# Access Assessment Report

1 Kenneth Road & 265 Condamine Street, Manly Vale

**Reference No:** 112254-Access-r1

**Date:** 9 September 2020

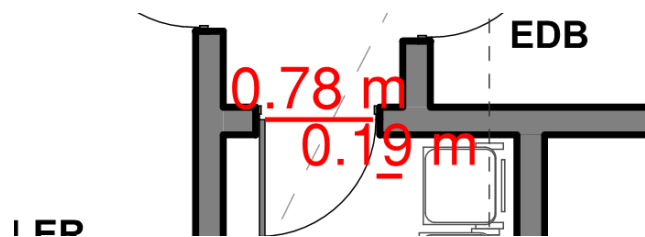
- 3.1.1. Provide 530mm latch-side circulation on the approach side to the platform lift doors in accordance with Clause 13.3 of AS1428.1-2009, or confirm the specifics of the door operation (i.e. push button with automatic door opener) to ensure that persons in wheelchairs are able to independently use the low-rise platform lift.

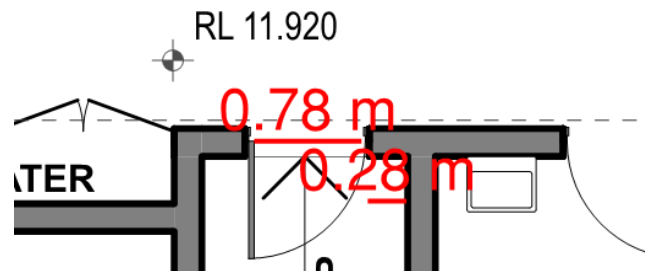
- 3.1.2. Provide an 850mm clear opening width doorway with 510mm door latch circulation space to the lower ground floor Comm Bins Room in accordance with Clause 13.2 and 13.3 of AS1428.1-2009.

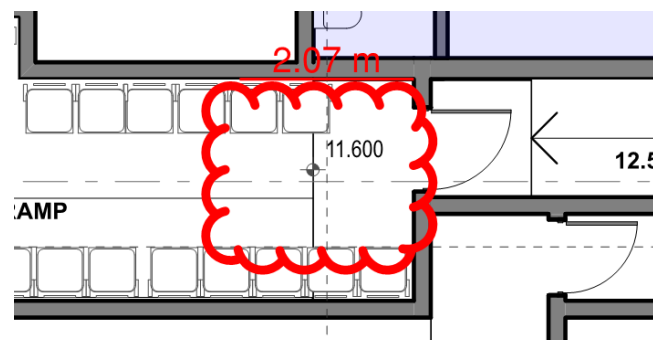
- 3.1.3. Provide an 850mm clear opening width doorway with 530mm door latch circulation space to the lower ground floor Bins Room in accordance with Clause 13.2 and 13.3 of AS1428.1-2009.

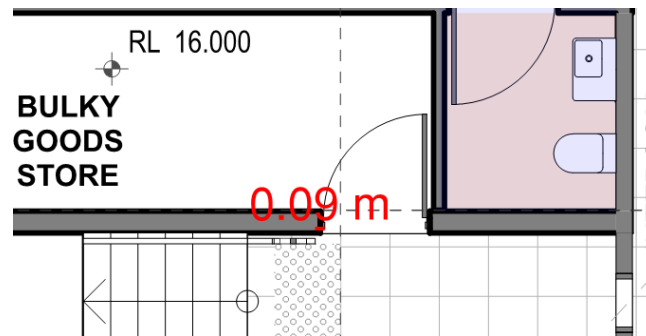
- 3.1.4. Provide a level (max 1:40) 1540mm wide x 2070mm deep wheelchair turning space within the lower ground floor Bins Room in accordance with Clause 6.5 of AS1428.1-2009 (note the bins are not considered as obstructions, thus the depth of the circulation space is the only technical non-compliance where the surface floor gradient exceeds 1:40).

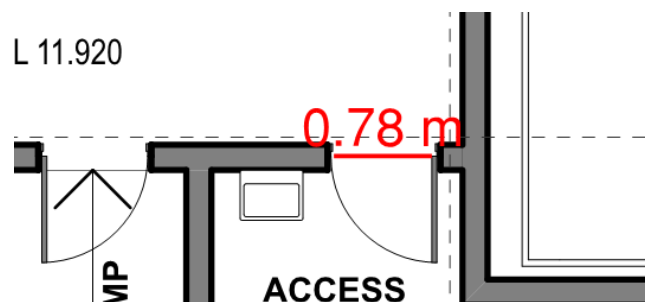
- 3.1.5. Provide 510mm door latch circulation space (clear of the stairway handrail) to the Level 01 Bin Room in accordance with Clause 13.3 of AS1428.1-2009.

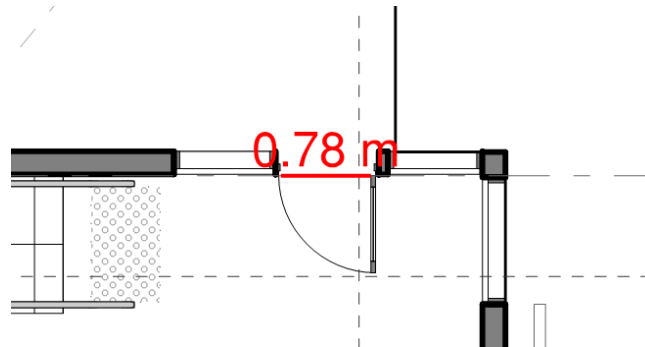
- 3.1.6. Provide doorways with a clear opening width of not less than 850mm to both Access WCs in accordance with Clause 13.2 of AS1428.1-2009.

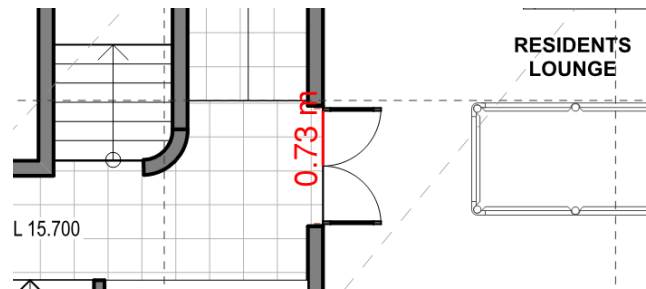
- 3.1.8. Provide an 1800mm wide x 2000mm deep wheelchair passing space to the Level 01 residential public corridor where this is currently greater than 20m between passing spaces in accordance with Clause 6.4 of AS1428.1-2009.

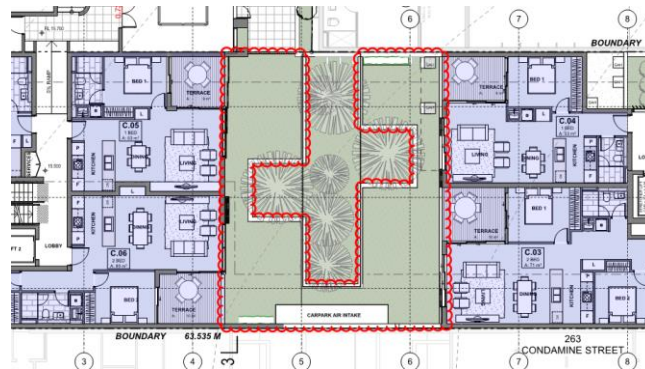
- 3.1.9. Provide doorways with a clear opening width of not less than 850mm to all doorways around the resident's areas on Level 01 in accordance with Clause 13.2 of AS1428.1-2009.

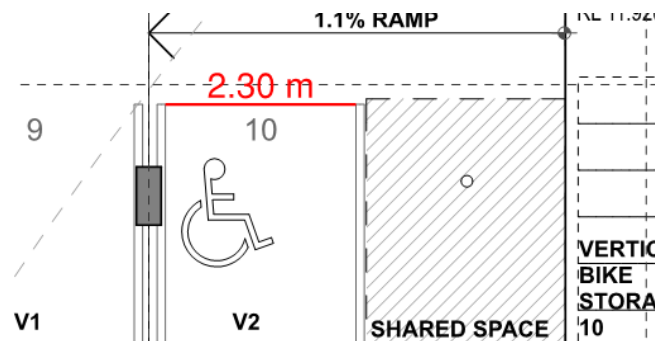
- 3.1.10. Provide wheelchair trafficable ground surfaces to the resident's garden area to ensure that persons in wheelchairs can circulate within and throughout the space in accordance with Clause 7 of AS1428.1-2009 (however refer comments in BCA report regarding access to this area and the implications under BCA C3.11(g)).

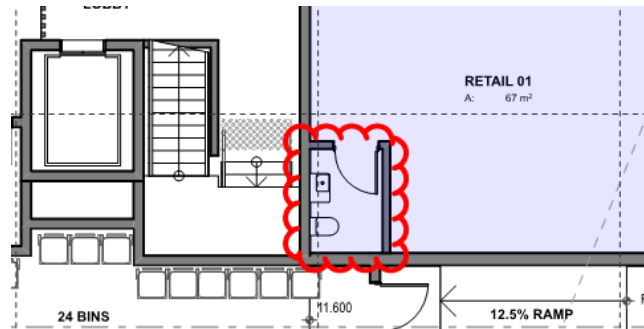
- 3.1.12. Provide tactile ground surface indicators (TGSIs) with a depth of between 300-400mm where the landing depth is less than 3000mm, and with a depth of between 600-800mm where the landing depth is 3000mm or more. For example, the below TGSIs shall be between 300-400mm only in accordance with AS1428.4.1.

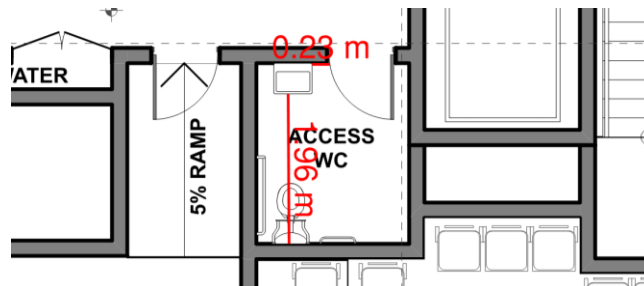
- 3.1.13. Provide ambulant unisex sanitary compartments to the two Retail tenancies (where not more than ten (10) people are employed) in accordance with Clause 16 of AS1428.1-2009.

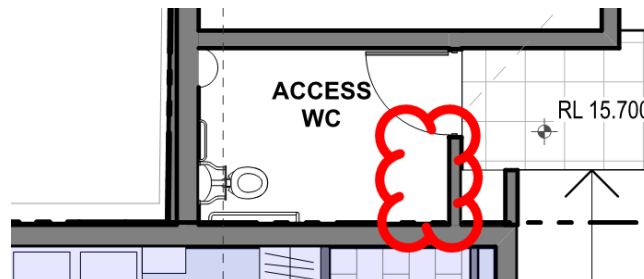
- 3.1.14. Provide a minimum 300mm clearance between the arc of the door swing, and a minimum 2300mm deep closet pan circulation space with a washbasin encroachment of not more than 100mm into the 2300 deep circulation space, to the lower ground floor accessible unisex sanitary compartment in accordance with Clause 15.2.8 and 15.6 AS1428.1-2009.

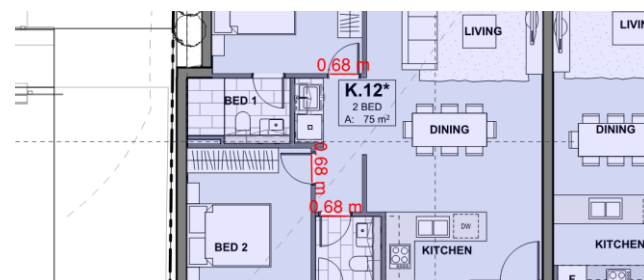
- 3.1.15. Provide a compliant washbasin to the Level 01 accessible unisex sanitary compartment in accordance with Clause 15.3 of AS1428.1-2009 (and be conscious of comments above).

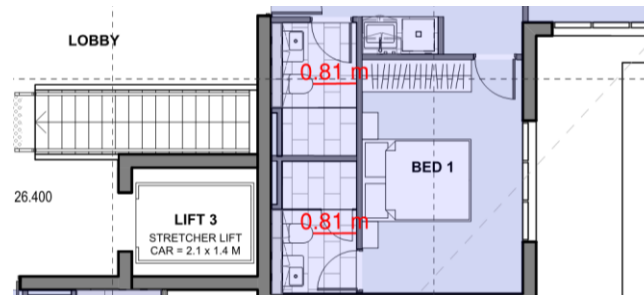
- 3.1.16. Provide a minimum 820mm clear opening width to all doorways internal to the livable units in accordance with Clause 3 of the LHDG (also ensure that all internal corridors maintain the required 1000mm clear width).

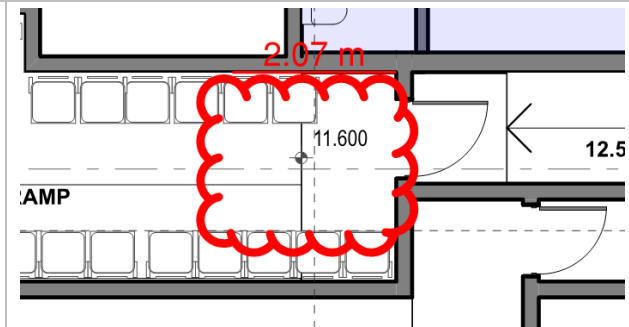
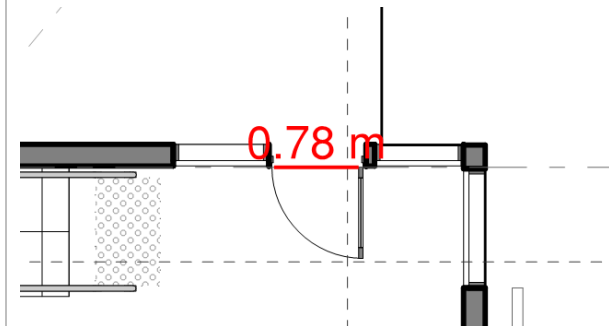
- d. The doorways leading to the Bin Room on Level 01 shall be provided with compliant door latch circulation space (510mm).

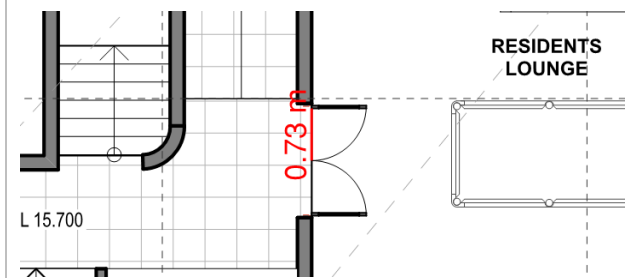
- e. The Lower Ground Bin Room shall be provided with a 1540x2070mm level (max 1:40) turning area.
